UNITED STATES PATENT AND TRADEMARK OFFICE

DATE MAILED: 10/02/2003

| APPLICATION NO. | FII | LING DATE | FIRST NAMED INVENTOR | ATTORNEY DOCKET NO. | CONFIRMATION NO |
|-----------------------|-----------------|---------------|----------------------|---------------------|-----------------|
| 09/737,770 | 70 12/18/2000 | | In-Duk Song | 8733.339.00 | 8950 |

| · • | | | <u> </u> | |
|--|--|--|--|---------------------|
| | Office Action Summary | Examiner | Art Unit | |

FIG.2E

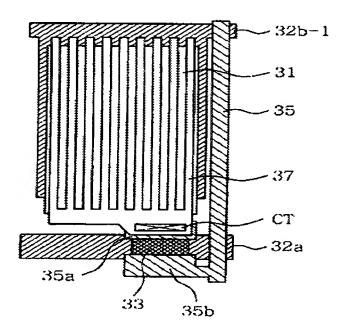
Jeon discloses in Figures 2A-2E, an in-plane switching LCD device comprising: a gate line, 32a, on a first substrate; a data line, 35, on the first substrate, the data line being perpendicular (as illustrated) to the gate line; a common line, 32b-1, on the first substrate, the common line being parallel (as illustrated) with the gate line and being formed of a metal (Cr for both gate line and common line; col. 2, lines 49-58, especially lines 55-58) (Applicant's wherein the common electrode is formed on the substrate like

the gate line); a pixel electrode, 37, (ITO; col. 3, lines 18-22) and the common electrode, 31, (ITO; col. 2, lines 64-67) being formed of a transparent conductive material (ITO); and a liquid crystal layer between the first and second substrates (inherent to comprising a LCD device) made by a method that simplifies the process by reducing the mask number.

Jeon is evidence that ordinary workers in the art of liquid crystals would find the reason, suggestion, or motivation to modify the LCD design to permit manufacture by the method of Jeon to simplify the process by reducing the mask number.

Therefore, it would have been obvious to one having ordinary skill in the art of liquid crystals at the time the invention was made to modify the LCD of APA with the specific layered structure of Jeon to permit manufacture by the simplified process of Jeon to reducing the mask number.

FIG. 3

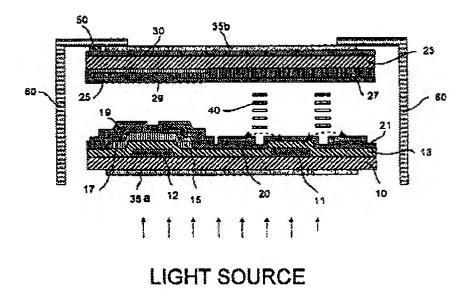
Son teaches in Figure 3, an LCD device, further comprising a light-shielding layer, 25, (Applicant's black matrix) on the second substrate, 23, (para 0029).

Son is evidence that ordinary workers in the art of liquid crystals would find the reason, suggestion, or motivation to use a black matrix on the second substrate to prevent light from leaking around the TFT (first two lines of para 0029).

Therefore, it would have been obvious to one having ordinary skill in the art of liquid crystals at the time the invention was made to modify the LCD of APA in view of Jeon with the black matrix on the second substrate of Son.

FIG.1 (PRIOR ART)

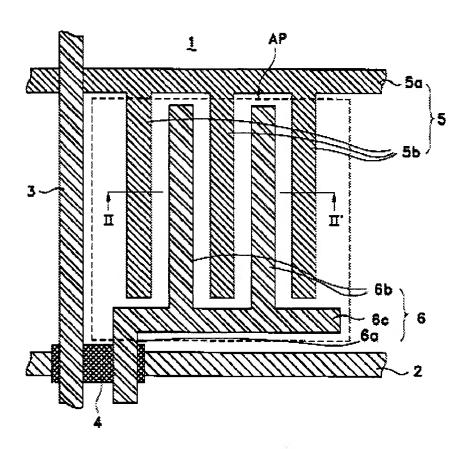
Shin teaches as prior art in Figures 1 and 2 the use of a pixel electrode, 6b, formed of an opaque metal (col. 2, lines 3-6) in order to block a light of the area in which the liquid crystal molecules are not operated in an in-plane switched LCD.

Shin is evidence that ordinary workers in the art of liquid crystals would find the reason, suggestion, or motivation to add opaque metal electrodes in order to block a light of the area in which the liquid crystal molecules are not operated.

Therefore, it would have been obvious to one having ordinary skill in the art of liquid crystals at the time the invention was made to modify the LCD of APA in view of Jeon with opaque metal pixel electrodes of Shin.
